RE: Staff Review Comments for Preliminary Level I Site Alteration Plan

Project Name: EcoMaine Parking Expansion
Address: 64 Blueberry Road
Applicant: EcoMaine
Planner: Nell Donaldson

Project ID: 2012-653
CBLs: 238-A-008001, 239-A-002

Level I Site Plan Application – Ecomaine Parking Expansion

WEST SIDE SITE PLAN
SCALE 1"=20'

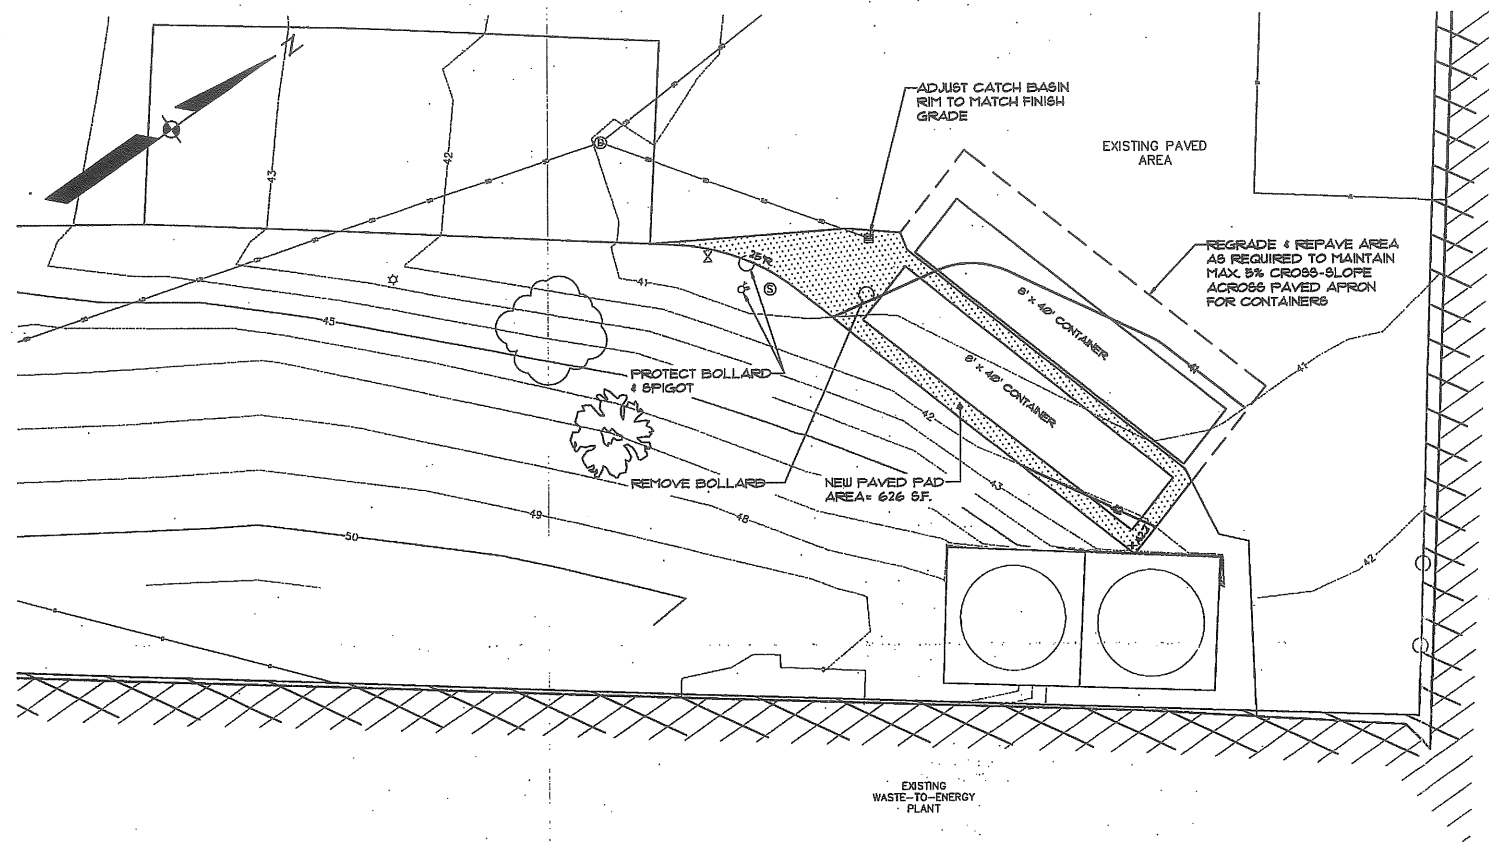
- a. Second Paragraph: "In addition to the items currently included on the plans, the Applicant should add notes and details for catch basin inlet protection for the two existing catch basins located in close proximity to the construction area on the "West Side Site Plan". Sheet 2.

Sheet 3 was revised to show inlet protection symbols at the two locations suggested as well as at 2 additional catch basins at the east side of the facility. Also, inlet protection notes and details were added to Sheet 4.

SHEET 3 OF 5

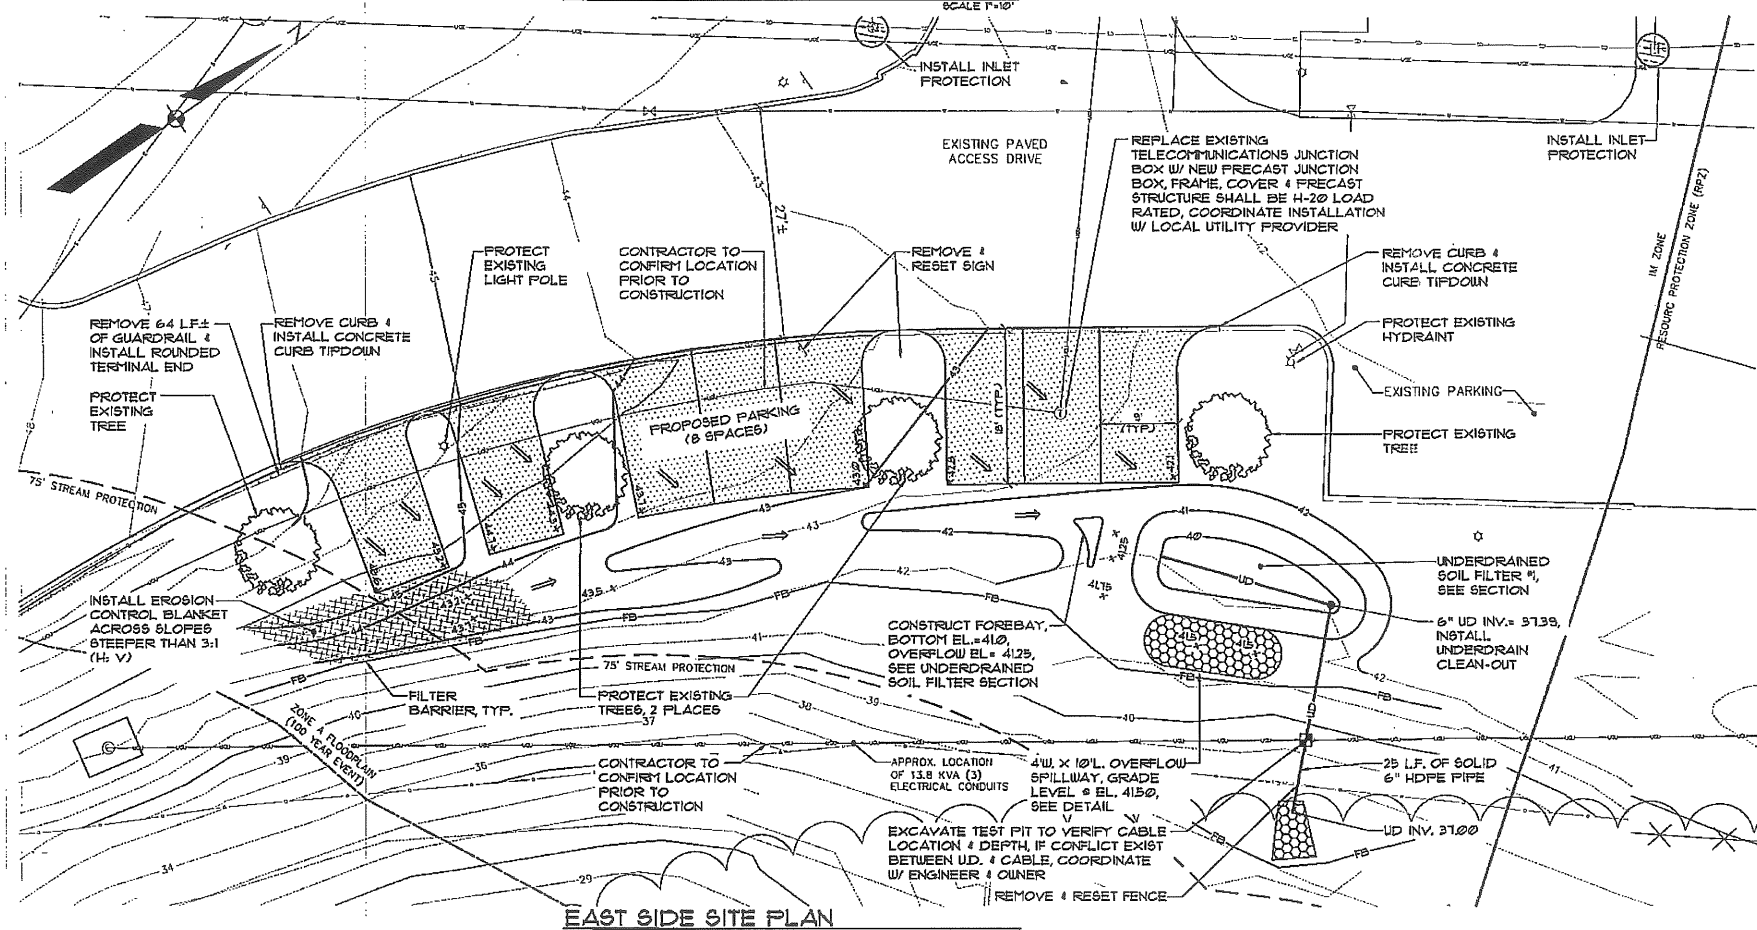
- a. Second Paragraph: "In addition to the items currently included on the plans, the Applicant should add notes and details for catch basin inlet protection for the two existing catch basins located in close proximity to the construction area on the "West Side Site Plan". Sheet 2.

Sheet 3 was revised to show inlet protection symbols at the two locations suggested as well as at 2 additional catch basins at the east side of the facility. Also, inlet protection notes and details were added to Sheet 4.

SHEET 5 OF 5

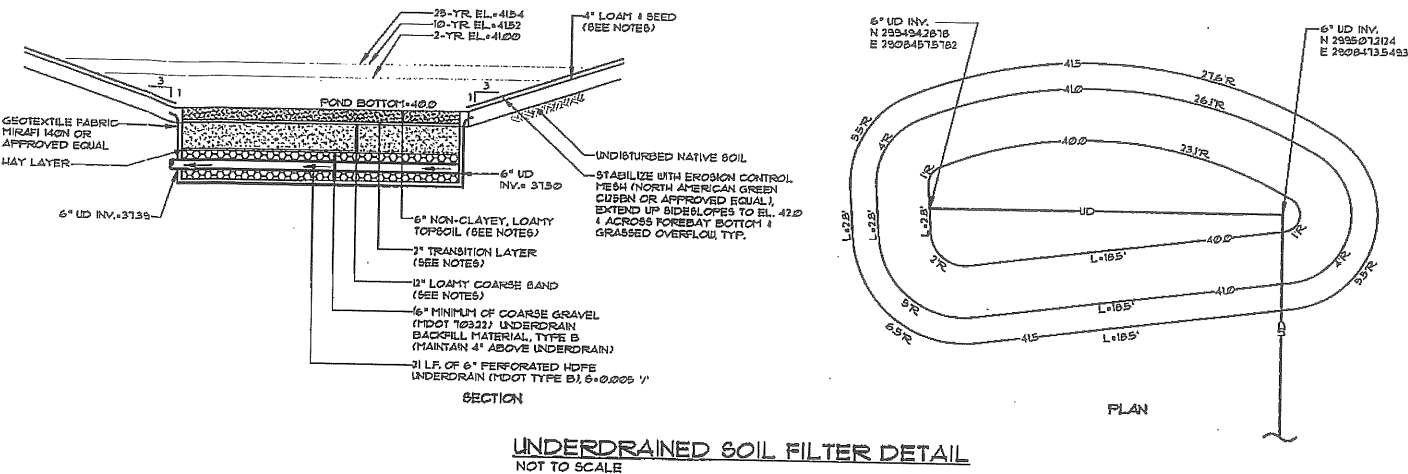
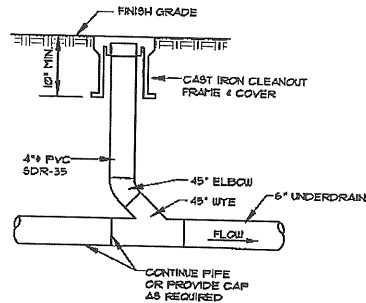
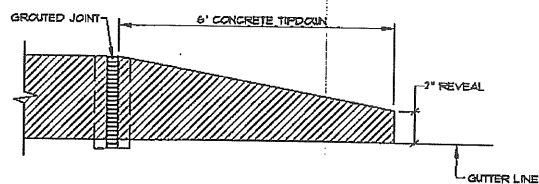
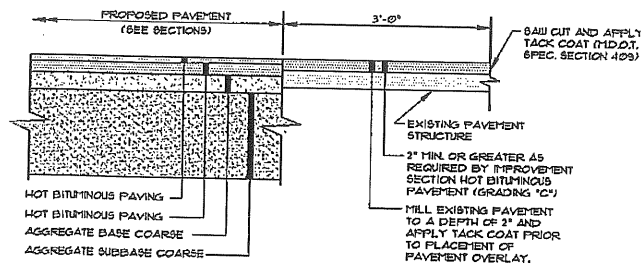
Last Paragraph: "The applicant's submittal should include a post-development stormwater inspection and maintenance plan for the proposed USF developed in accordance with and in reference to Maine DEP Chapter 500 guidelines and Chapter 32 of the City of Portland Code of Ordinances.

Specific maintenance requirements are provided on Sheet 5. Ecomaine is in the process of updating their Operations and Maintenance Manual. It will be submitted upon completion.
